**ARCHITECTURAL REVIEW BOARD  
MUNICIPAL PLANNING COMMISSION  
-AGENDA-  
Thursday, December 8, 2016 at 7:00 P.M.**

## MEMORANDUM

SUBJECT: Staff Memo for the Meeting of December 8, 2016

# 882 High St.

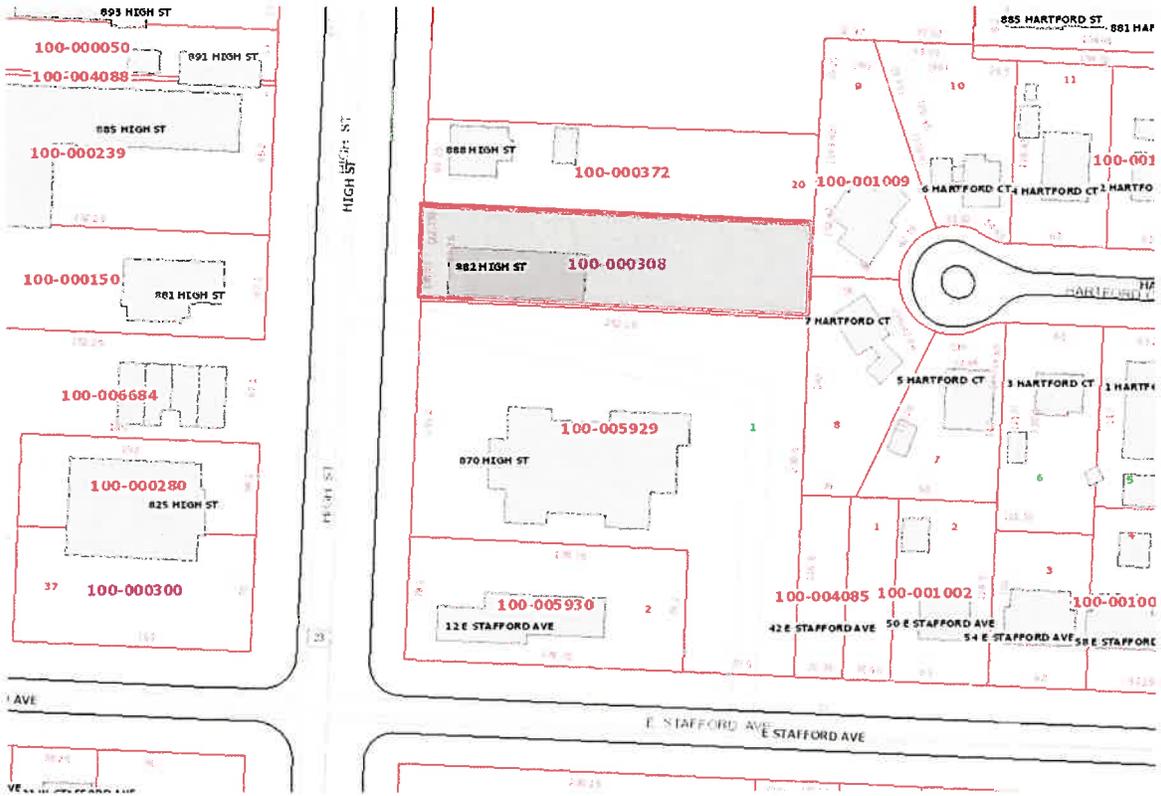
Staff is recommending *modification* of this application. Basic business names, graphics and addresses on signs provide a simpler and clearer view for motorists. At the very least, matching as many fonts and sizes of lettering as possible would help to simplify the look of the sign.

We cannot change the Leading RE logo but could try to match the font of the [www.camtaylor.com](http://www.camtaylor.com) with the Block portion of the Leading RE and/or remove Love Columbus etc.

SITE DIMENSION PLAN

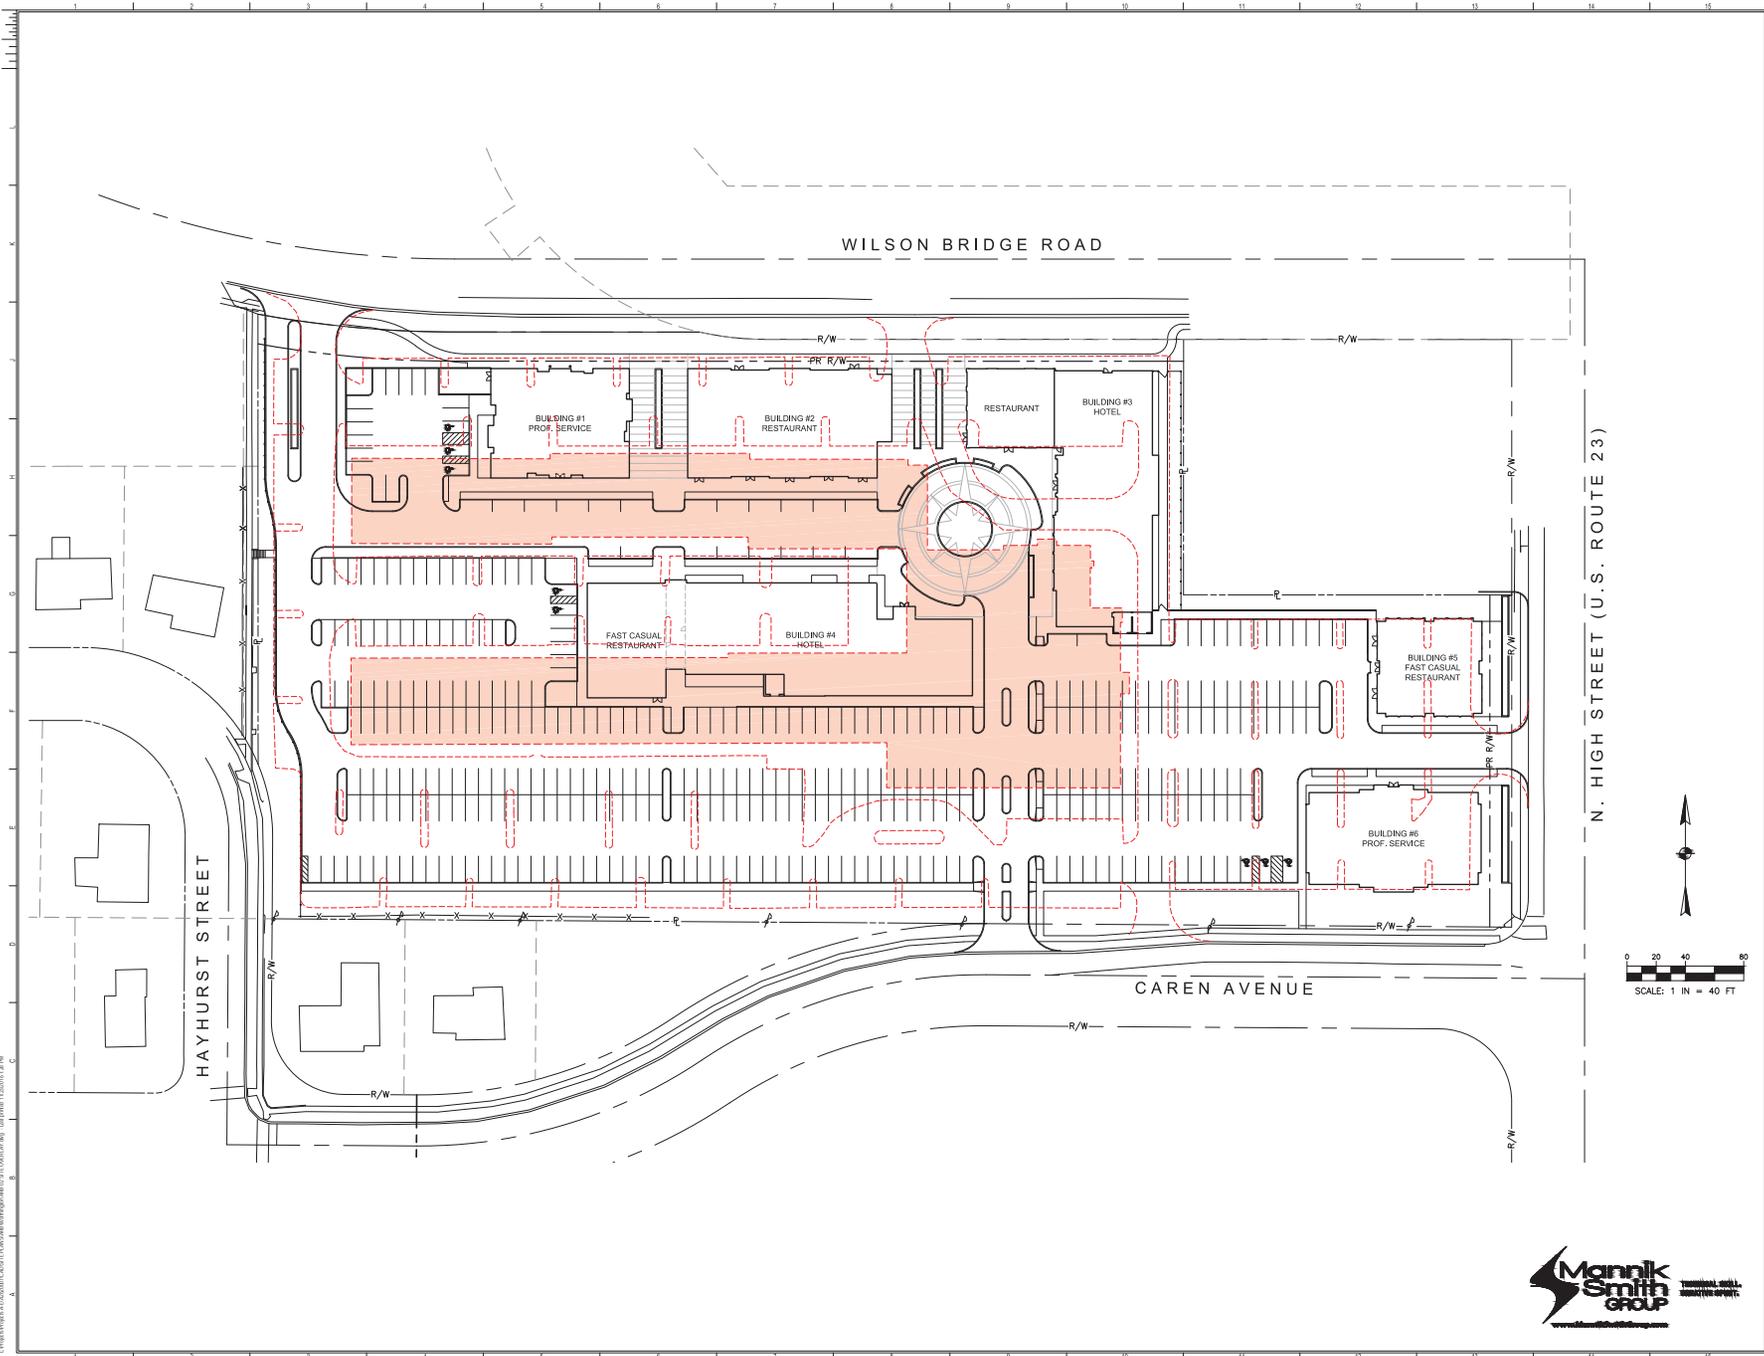
1. *The proposed site plan generally reflects the discussions at the ARB meetings, and is appropriate for the site. Elimination of the sidewalk near Wilson Bridge Rd., and widening of the sidewalk near the buildings are appropriate. The more prominent planting area would be attractive, and the distance from the road would be safer for pedestrians.*

JOB NO.	SHEET NO.
	<b>A1</b>
DRAWN BY	CHECKED BY
DATE	STORE NO.
11.17.16	613

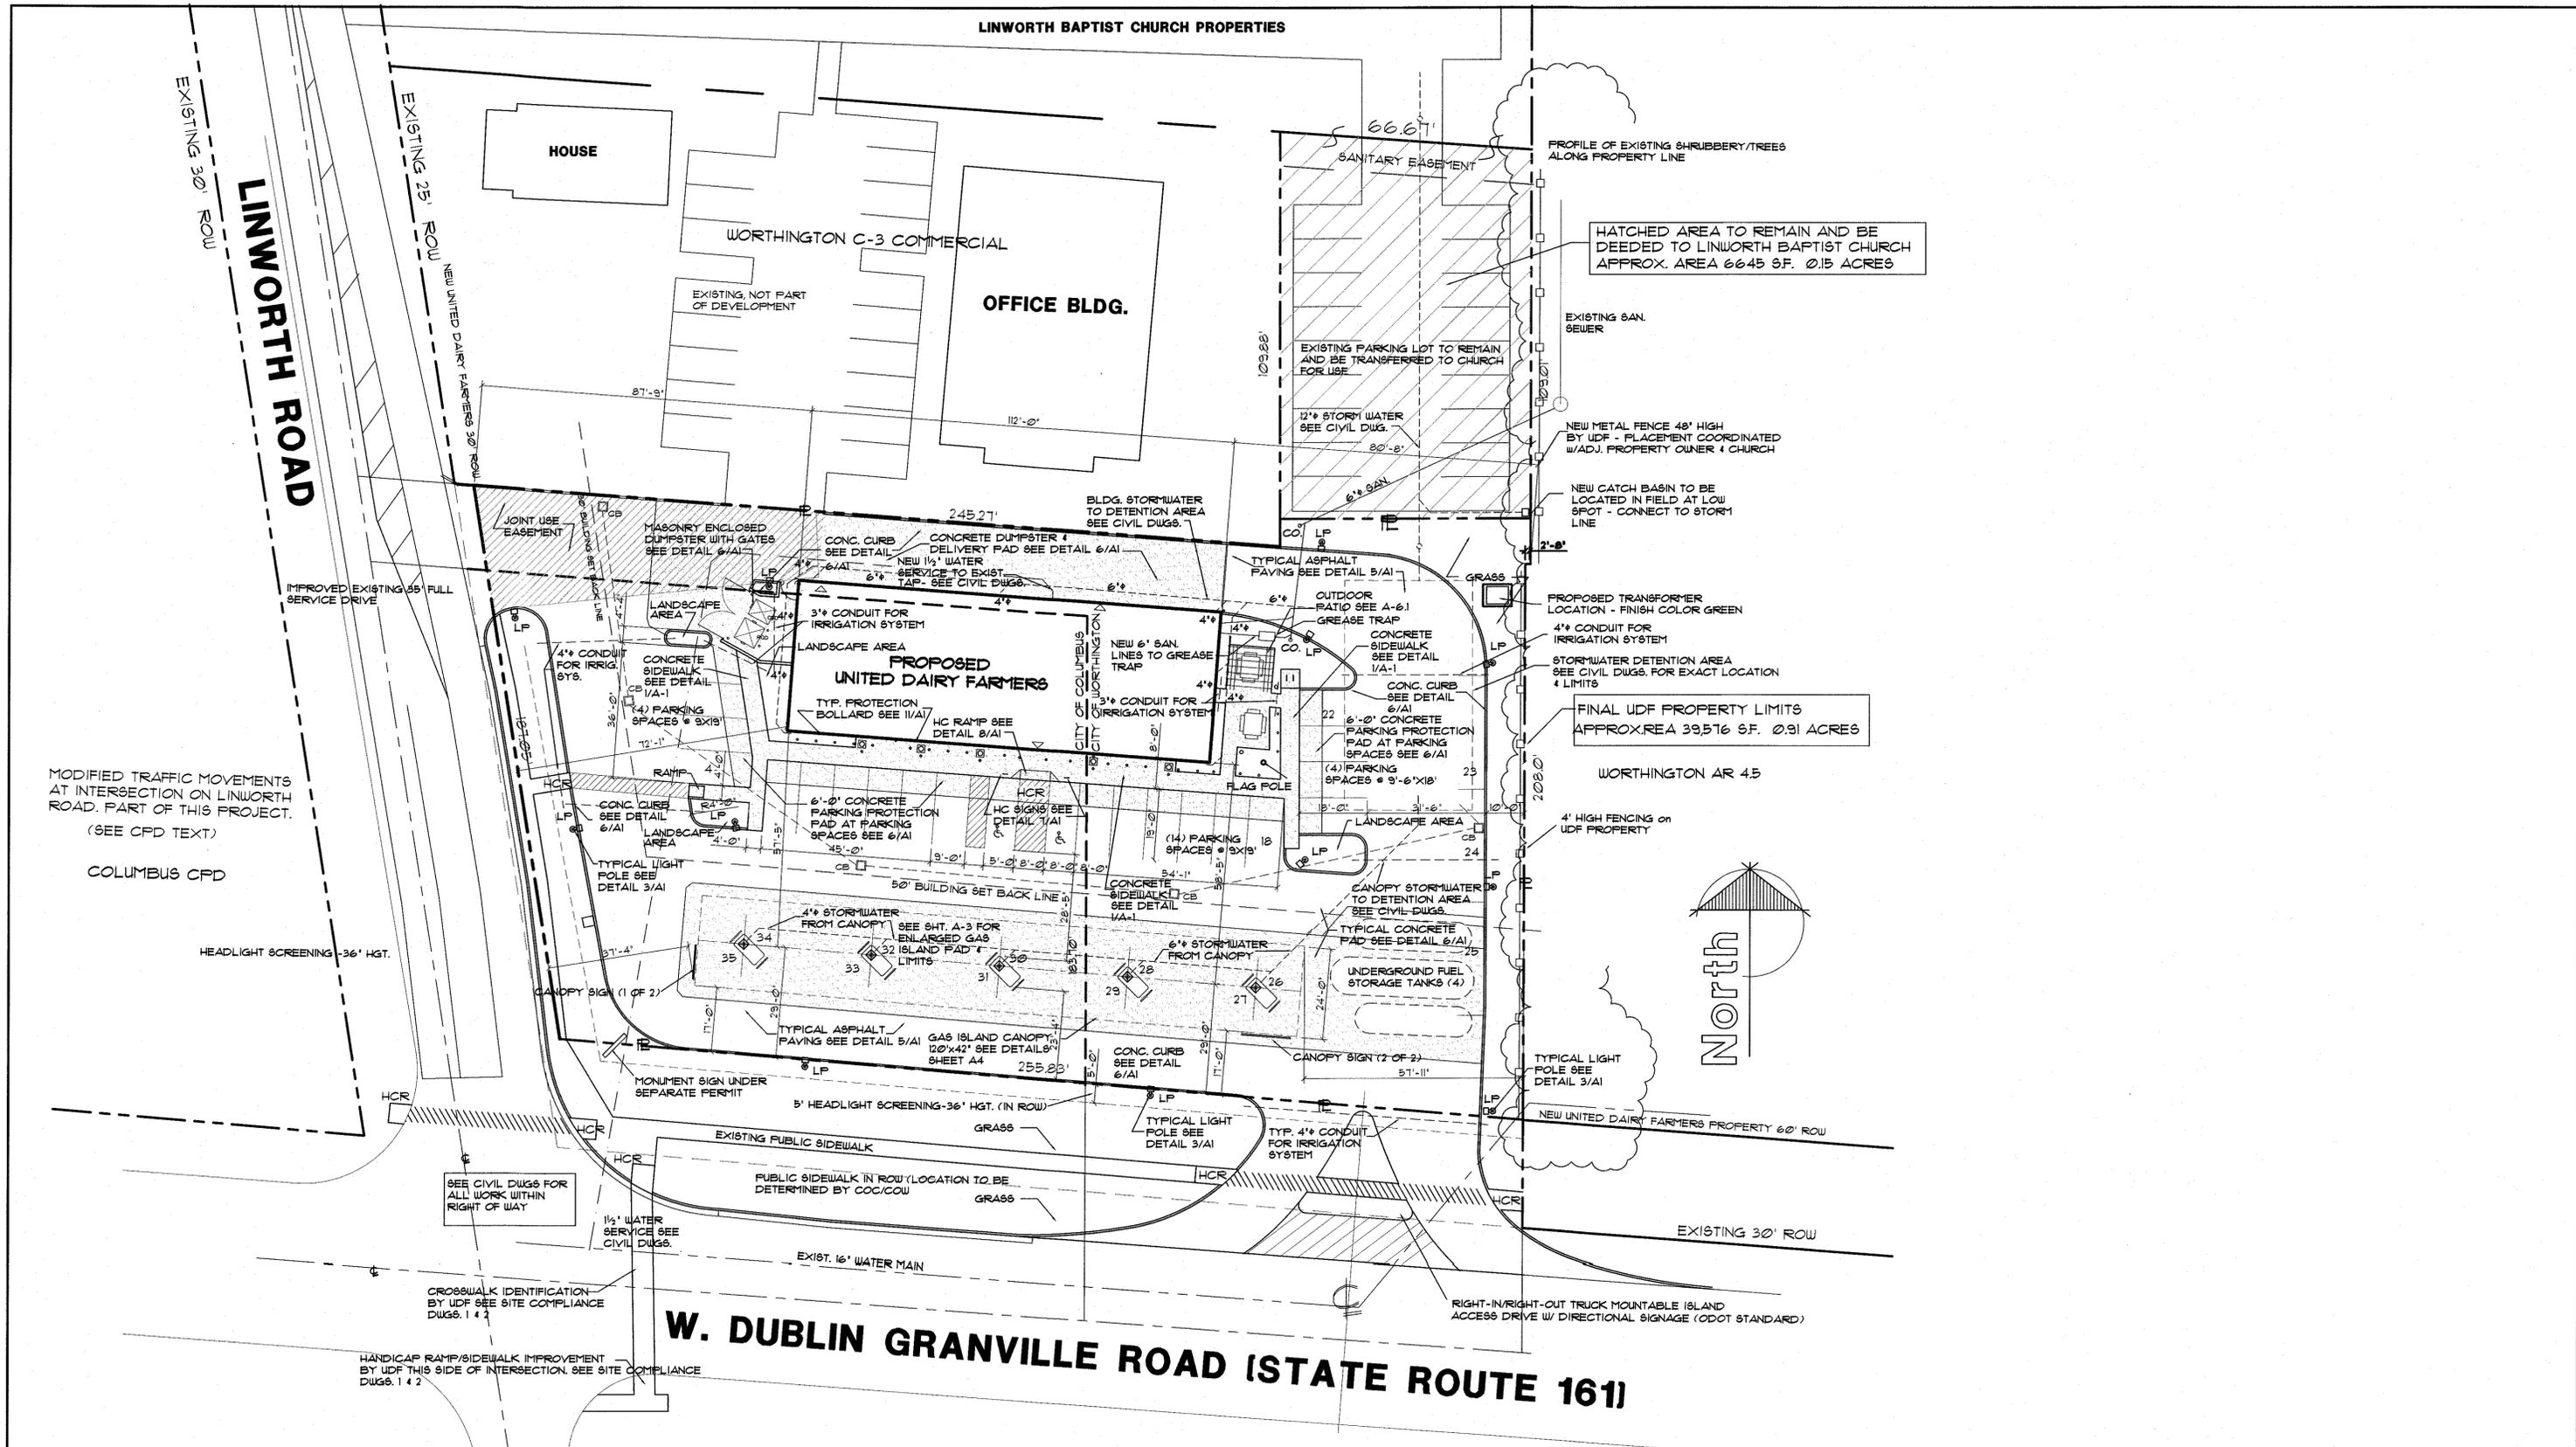
7. The light poles were proposed to have a ground to fixture height of 15’, including a 2’ exposed concrete base. The detail on sheet A1 shows the fixture at 17’ above grade. Two similar fixture styles have been submitted. Both styles have optional shields for the fixtures adjacent to the east side so light would not spill onto the residential property. The LEDs for both come in 5000k or 4000k color temperature. As was approved by the ARB, the photometric drawing indicates light levels no greater than 30 footcandles in any location.

- At the residential property line, the illumination should not exceed 0 footcandles. Also, color temperature is typically approved to be no greater than 2700K. Selection of different fixtures may be necessary. The color of the light poles and fixtures should be brown (bronze) or black.
- Although the freestanding and wall signs are not all in Worthington, the sign package should conform to the Worthington Design Guidelines and Codified Ordinances as closely as possible. Additional signs should not be added to the canopy and the freestanding sign should be smaller ( $\leq 30$  sf/side) with a brick base to match the building.
- The transformer must be screened with landscape material and be a color to blend in with the screening.

**DETAIL**  
TYPICAL BRICK PATTERN  
1" = 1'-0"

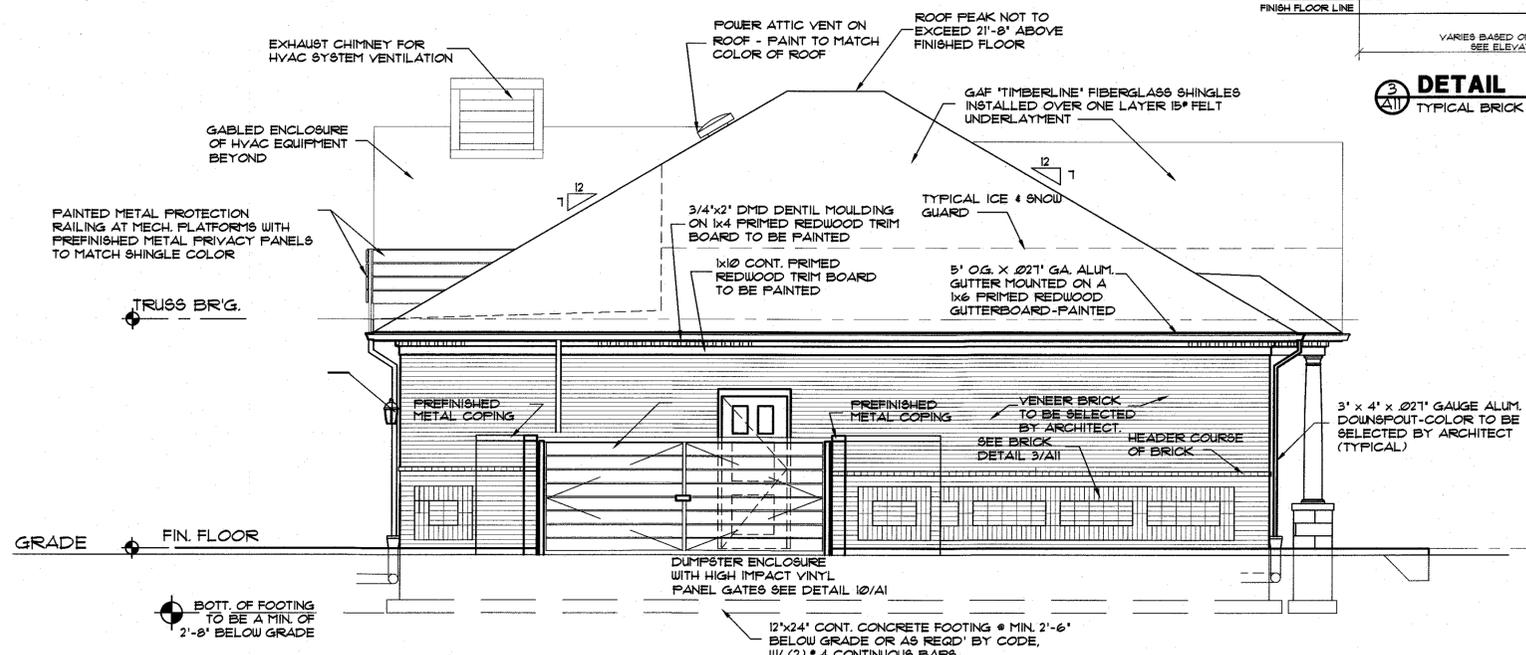
- The new building continues to be proposed as all brick, with a water table with a brick pattern around the entire building (see detail on A11).
  - The 7/12 roof pitch with a hipped roof would remain the same with this submittal.

# Mae Cedar

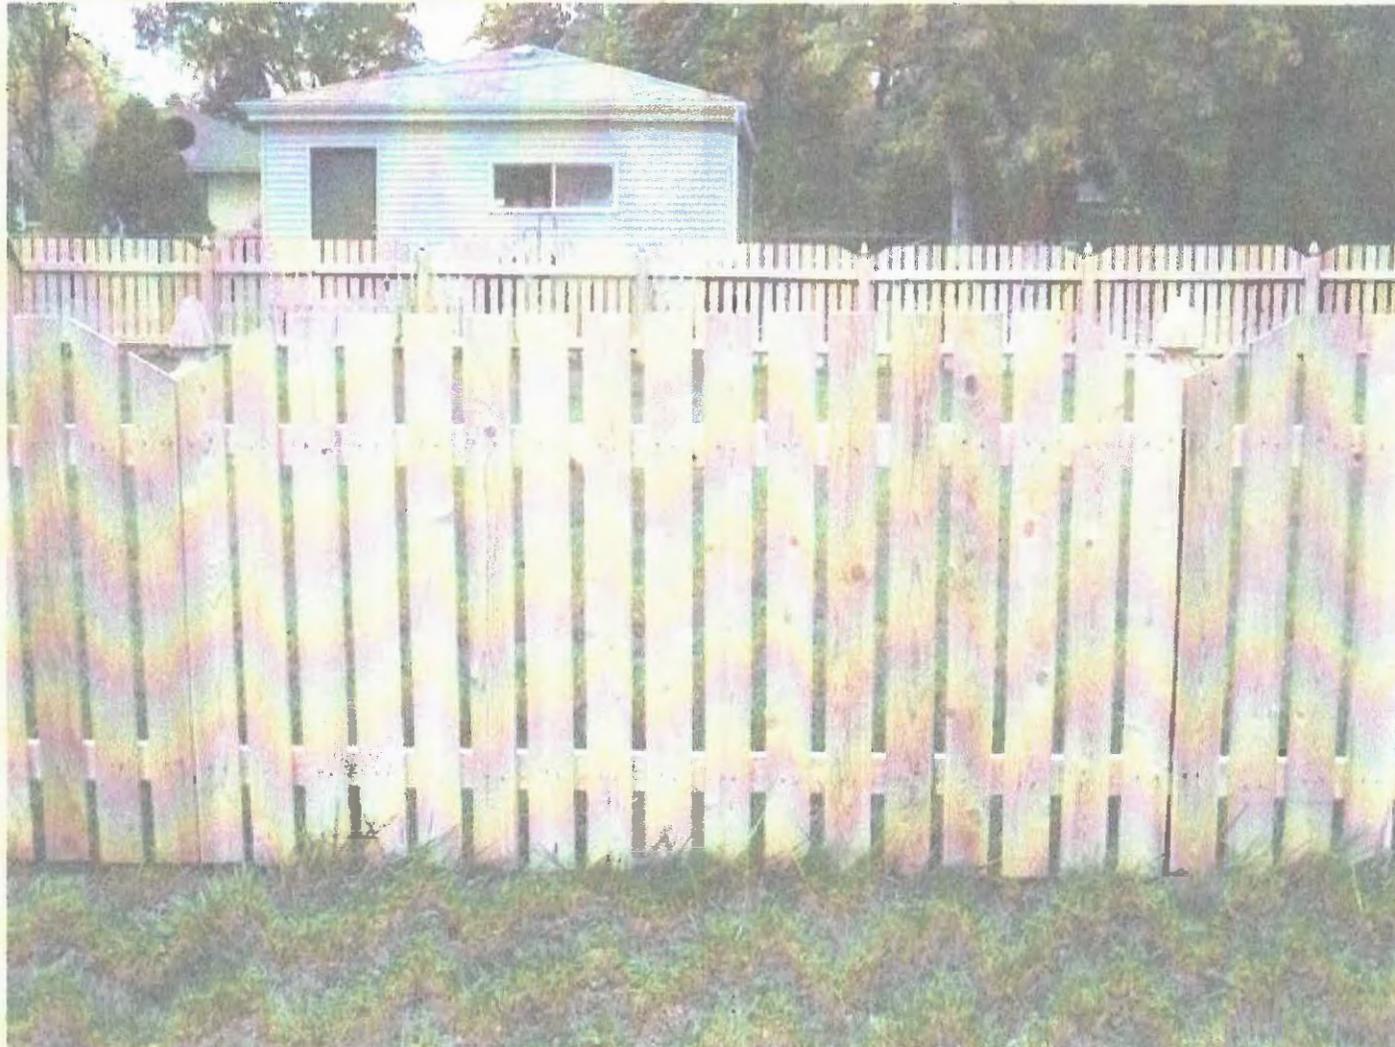
Staff is recommending *modification* of this application to have the spacing between the pickets equal to the picket width to create an open style fence as is called for in the Design Guidelines.
